Laurclavagh Renewable Energy Development Response to ACP FI reply from MKPO, Galway

Planning Reference: 319307

Date for Submission: 9th January 2026

Response to Further Information Laurclavagh Renewable Energy Development

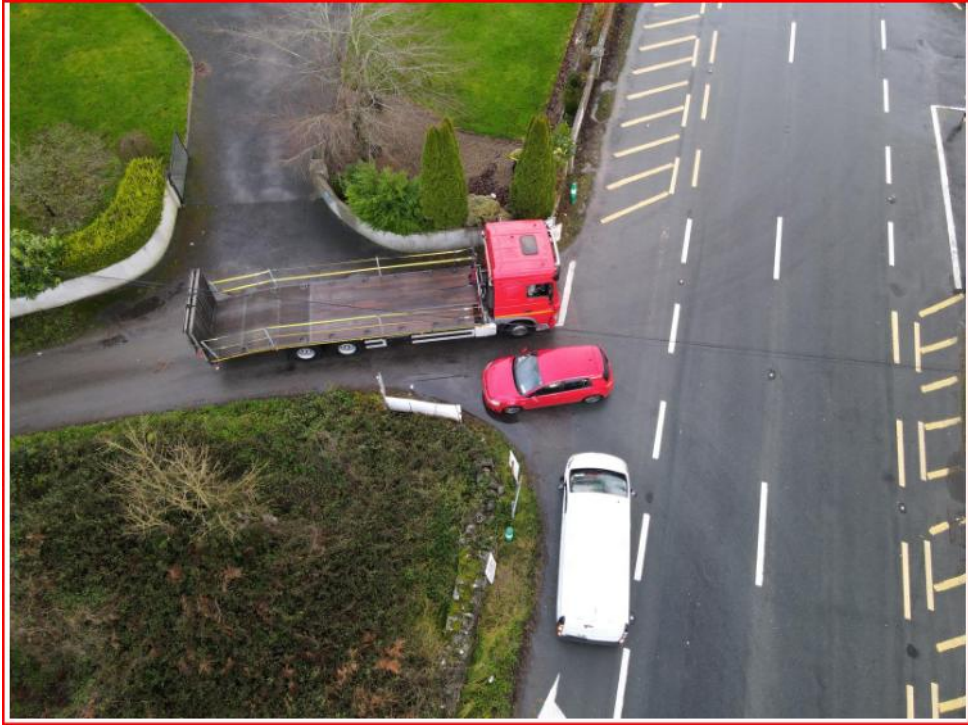
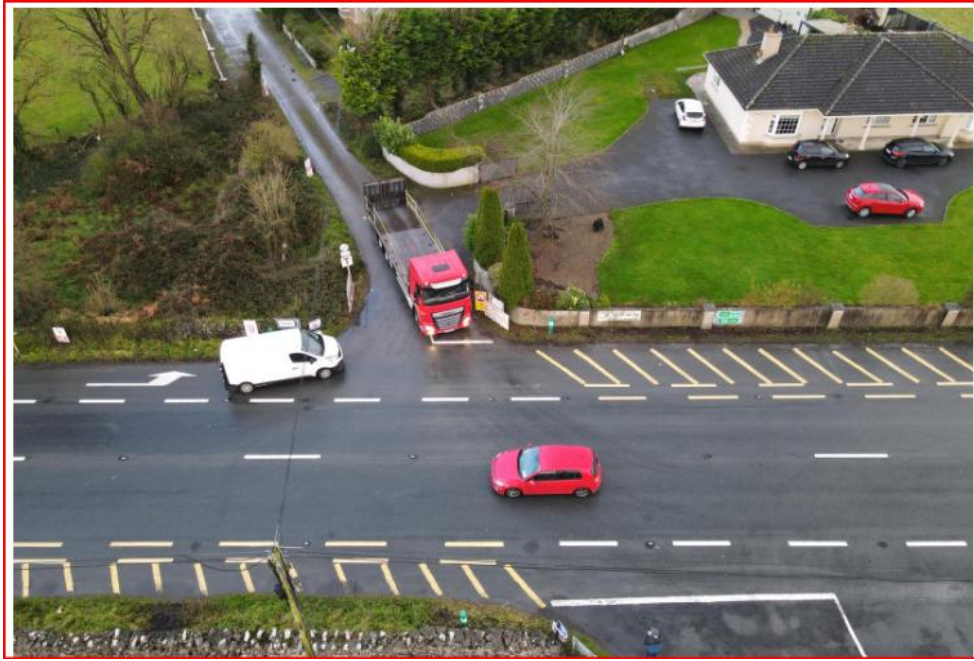
Note kerb radii at junction of 13m not available. Note inability to facilitate 2-way traffic on L61461. Note no right-turning lane on N83 from north. Thus queuing on the N83 for right turning onto the L61461 will occur and it is necessary to indicate Forward Sight Distances for Southbound traffic to these queuing vehicles from the centre of the N83 Southbound lane at a distance of 215m & compliance at 1.05m vertical profile.

Note that absence of kerb radii determines that HGV turning movement has to cross lane to contraflow lane to turn left.

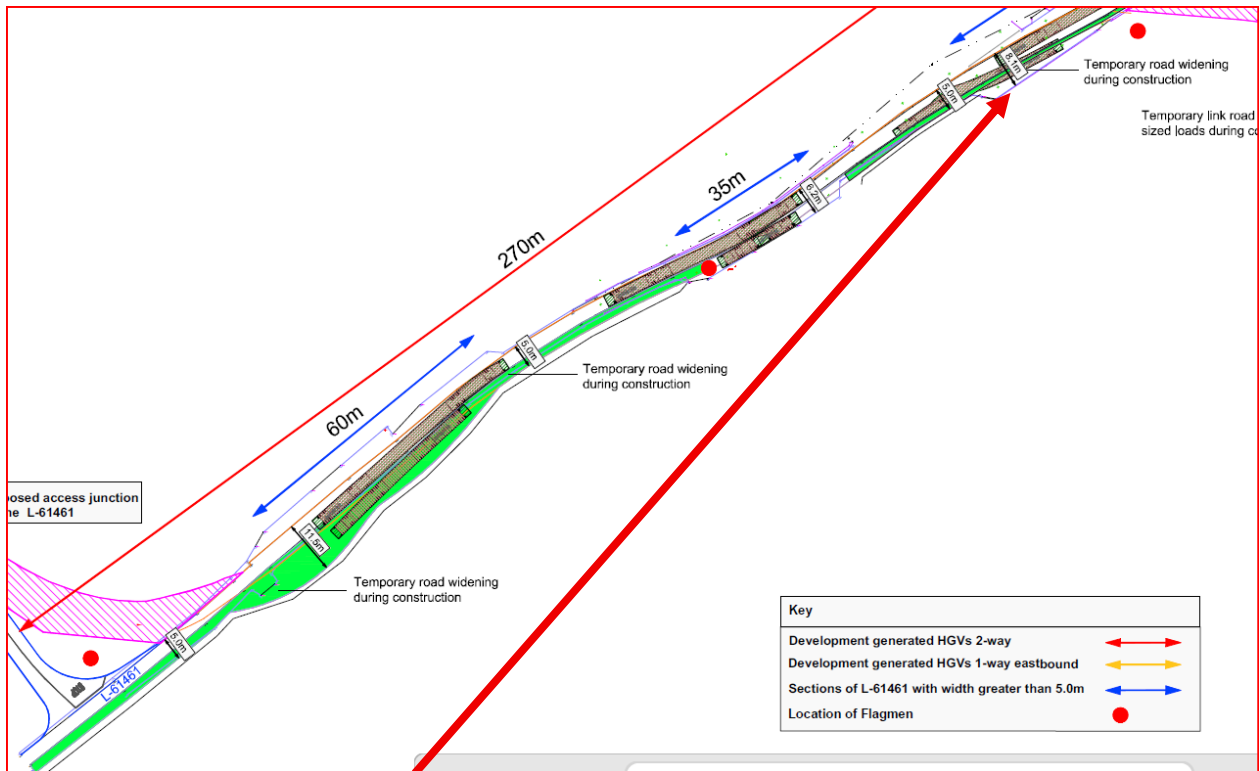
Note this photograph of 26/11/2025 shows Stop line at inside of carriageway edge from L-6146 on Eastern side of N83 facing Galway

Note there is no evidence that these lands are in the ownership/control of the Applicant. The owner objected to such usage on his property in the original file.

Figure 5.24 Priority Junction Stop Line with and without Hard Shoulder or Hard Strips

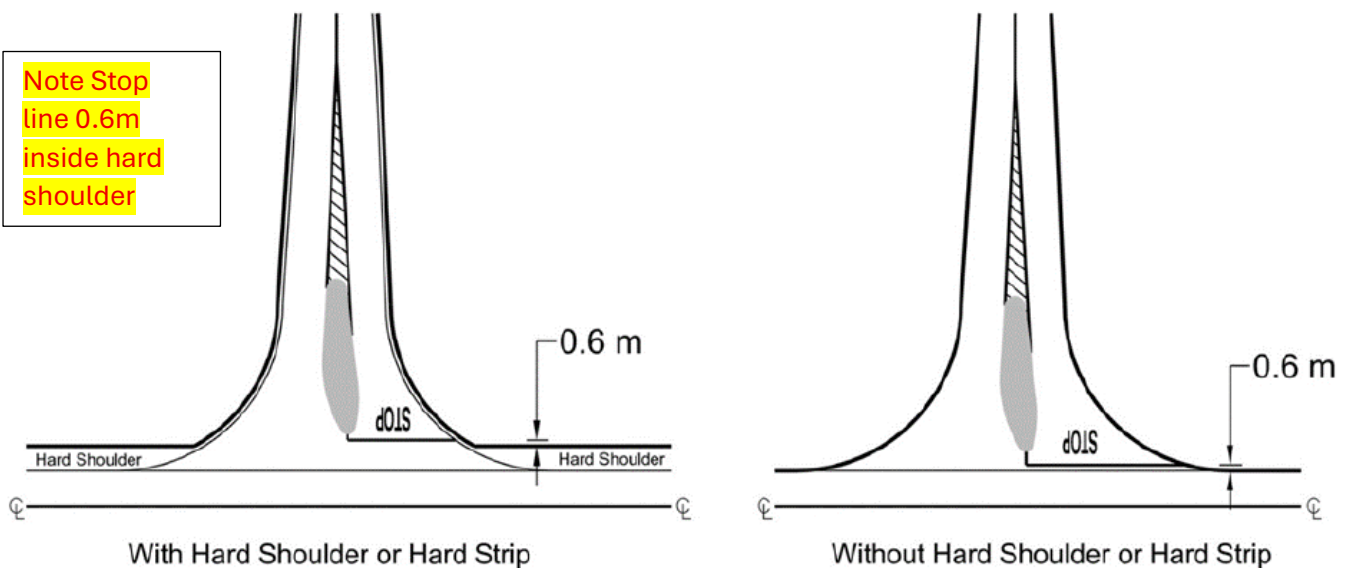
The TII Standard for junctions (Figure 5.24) from a minor road is included below & the Stop-line is shown at 600mm back from the inside of the hard shoulder edge. Suggesting that the moving of the Stop line out to the carriageway edge is a solution creates criminal negligence as trucks/vehicles do not have side lights that would identify them to N83 approaching vehicles. A cross hatched area is not visible at night-time. It is obvious that the writer of the Road Safety Audit chose to ignore this issue as any competent Auditor would identify the unsuitability of the junction. This is somewhat similar to the Gort Biogas [Appeal reference no. ABP-320207-24] entrance decision by the Supreme Court, where road safety was remitted back to ACP for reconsideration.

In accordance with the Traffic Signs Manual, the edge of the stop line nearest to the major road shall not be closer than 0.6m to the line of the back of the paved area of the major road including any hard shoulder or hard strip (see Figure 5.24).

Figure 15-17 Location 5 - Proposed access junction off the L-61461 for all traffic during construction and operational phases - visibility splays

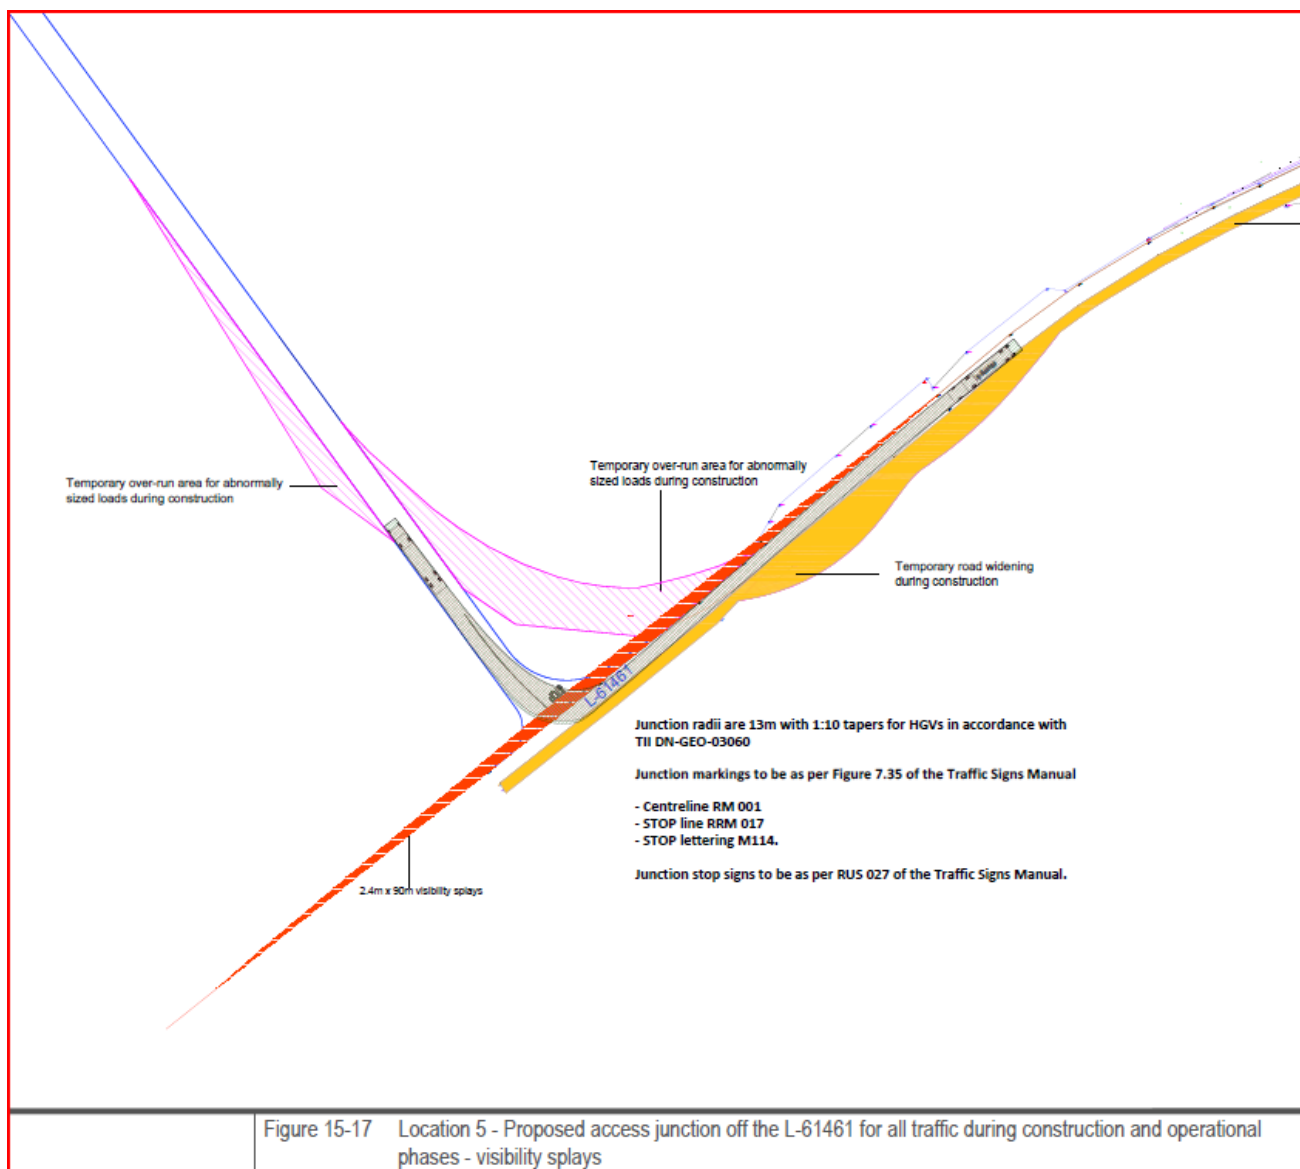
It is confirmed that the appropriate visibility splays as shown in Figure 15-17 of the EIAR will be kept clear of all obstruction during the construction, operational and decommissioning stages of the Proposed Project.
